REQUEST FOR PROPOSALS

**To Design and Construct
I-65 Southeast Indiana Project
Through a Public Private Agreement**

VOLUME II TECHNICAL PROVISIONS

**A Project of the
INDIANA DEPARTMENT OF TRANSPORTATION
ISSUED DECEMBER 28, 2016
ADDENDUM 2 ISSUED FEBRUARY 20, 2017**

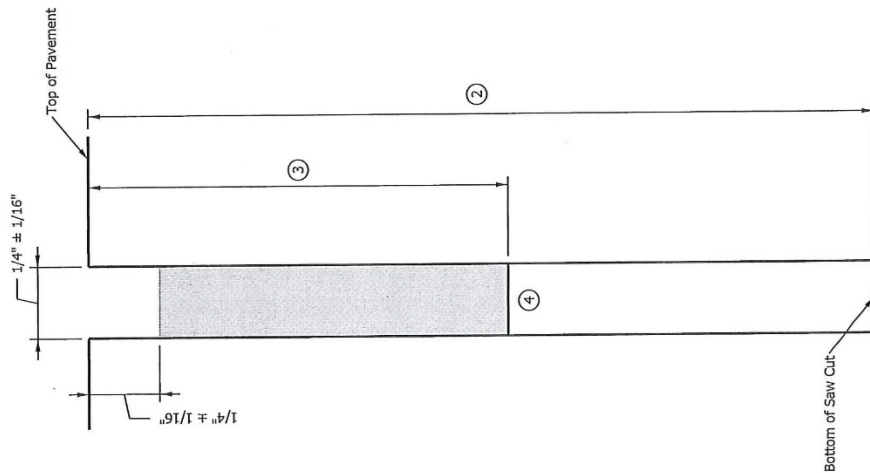
SECTION 503, BEGIN LINE 78, DELETE AND INSERT AS FOLLOWS:

construction traffic uses the PCCP prior to sealing. *The sawed joint shall be cleaned as specified in 503 05(a)*

TYPE D-1 SAWED CONTRACTION JOINT SEALANT

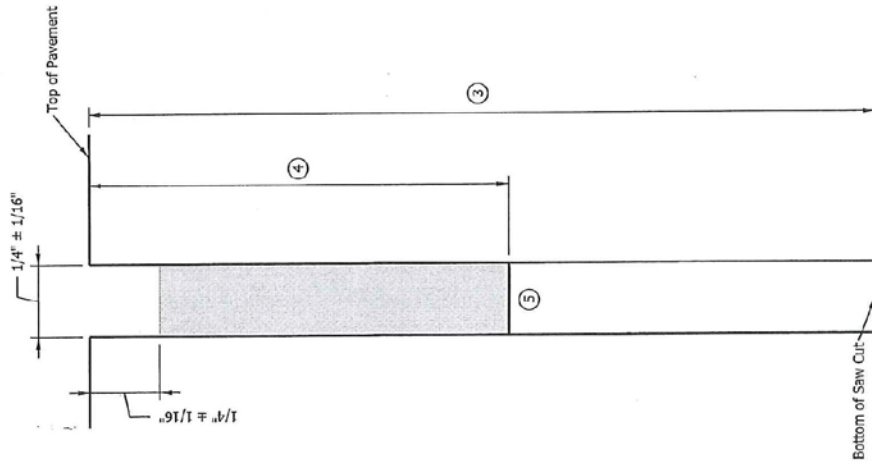
1. This detail is to be used in place of Standard Drawing E 503-CCPJ-06.
2. Transverse joints shall be constructed perpendicular to the centerline with maximum spacing of 18'-0" unless otherwise specified.
- ③ The depth of the saw cut shall be D/3 (-0, +3/8") "D" is defined on Standard Drawing E 503-CCPJ-01 and -02.
- ④ The depth of sealant shall be at least 2".
- ⑤ A backer rod shall not be installed.
